Presentation of main findings in report from:
**Norwegian Safety Investigation Authority (NSIA) related
to a high-speed frontal road-collision (GRSP-69-02)**

UNECE/GRSP-69/May 2021

Road 2020/07

*REPORT ON A HEAD-ON COLLISION
BETWEEN A PASSENGER CAR AND A
VAN ON THE E39 AT AUSTEFJORDEN,
VOLD, MØRE OG ROMSDAL ON
20 OCTOBER 2019*

Figure 19: Test of seat-back with 2 x 18 kg luggage and 10 kg against the head restraint in a sled test at 50 km/h. The minimum requirement for forward deformation of the seat-back is described below. Source: UN-ECE R17

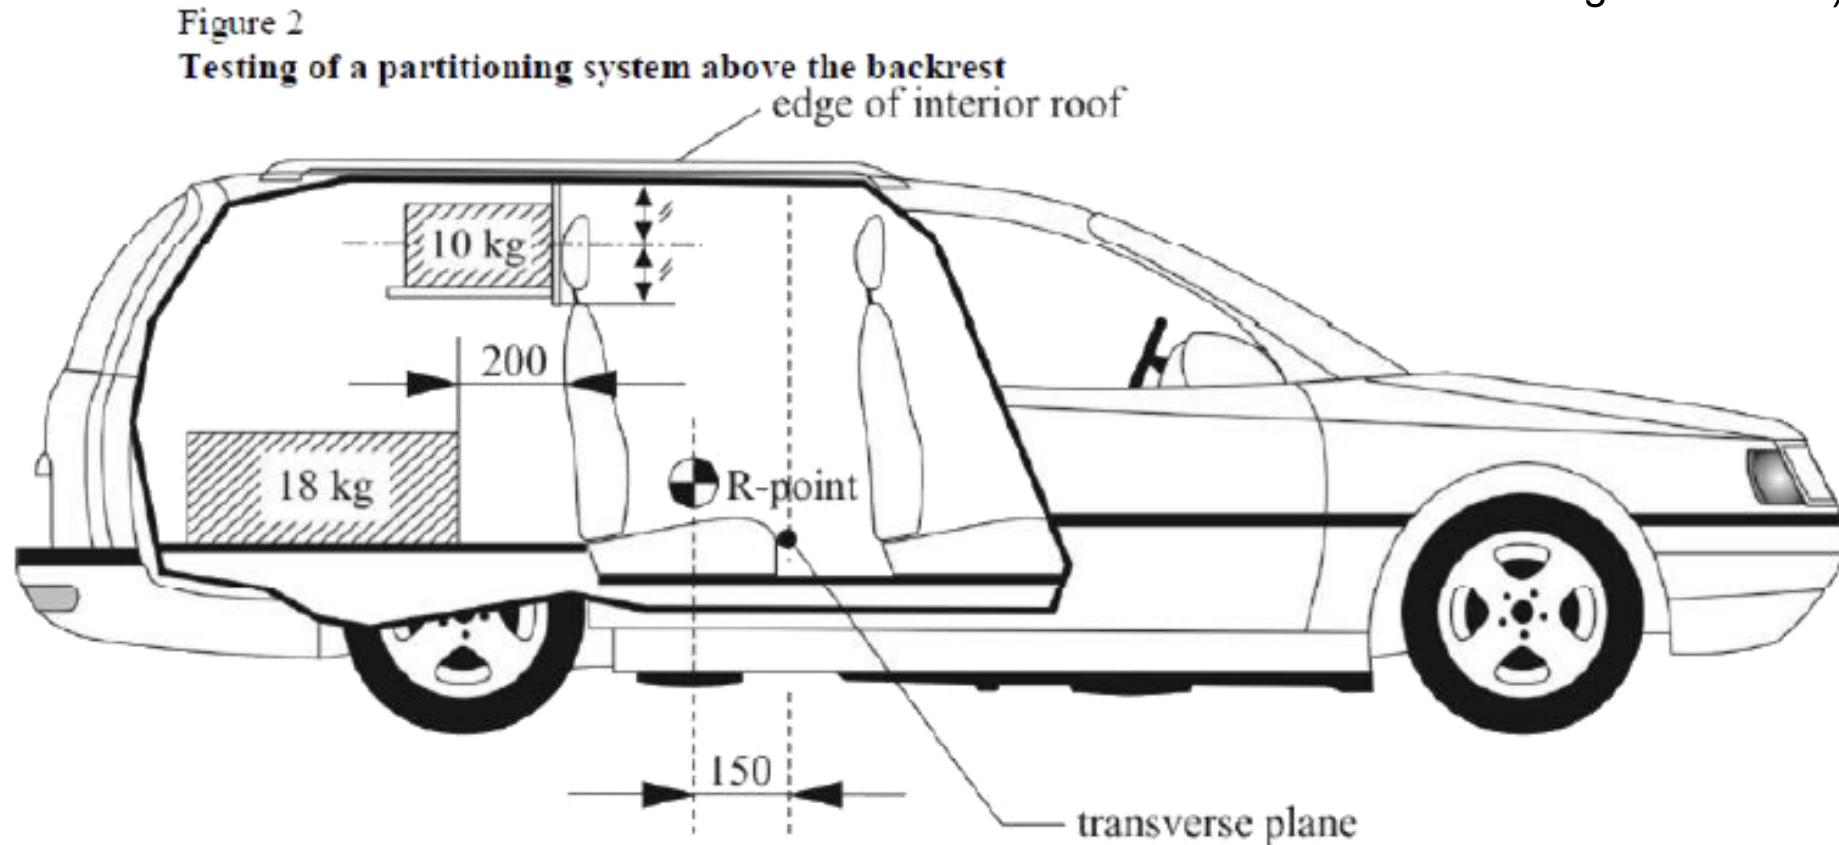
Discussion: What can be improved?

- Increase the test-mass (90 kg luggage proposed in 2003 by ANEC)
- Reduce allowed post-test deformation (100 mm/150mm)
- Add crash-test dummy(ies) in the seat during dynamic-test (without measurement)

Figure 25: Strength requirements for rear seat-backs - showing middle rear passenger and seat belts with alternative shoulder belt anchorages. (Note: R-point is determined by the car manufacturer and will vary). Illustration: NSIA

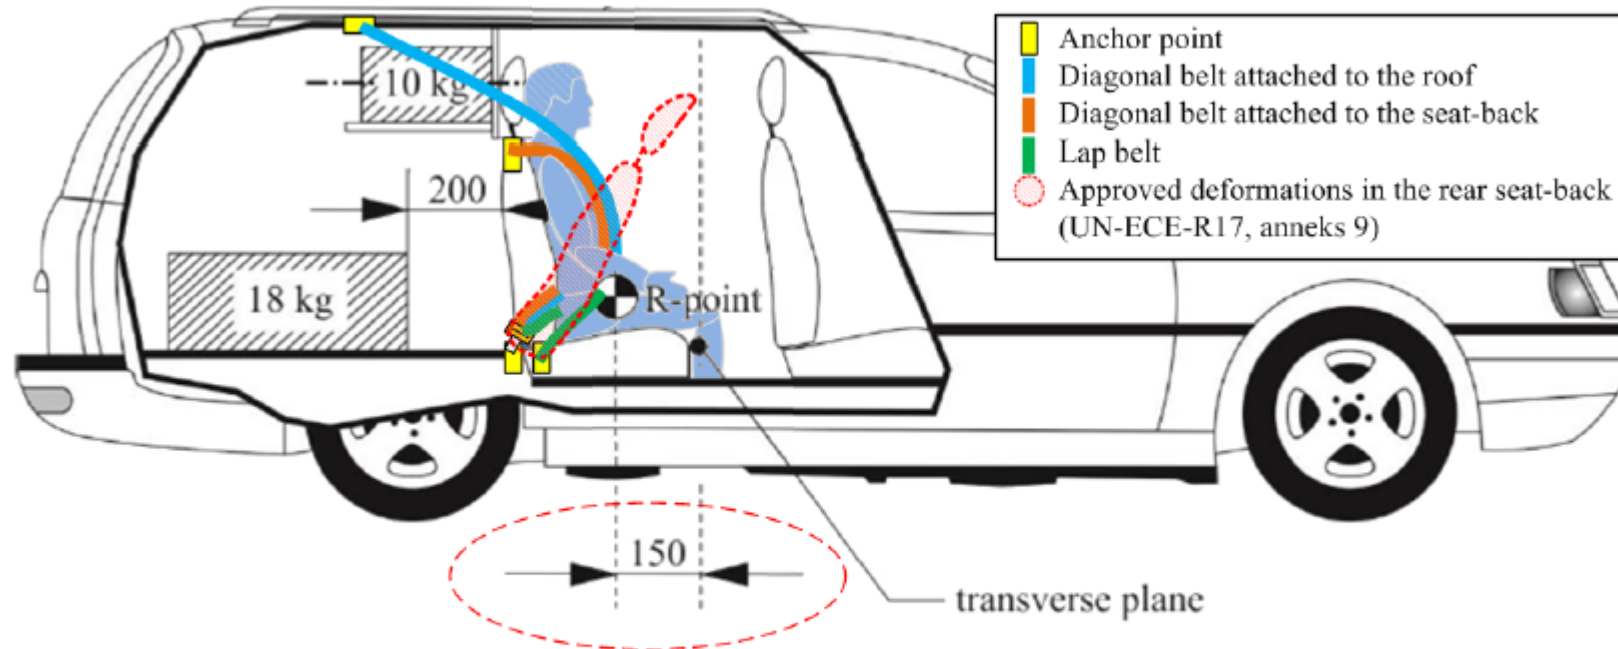
Focus on rear seat back with integrated belt-system
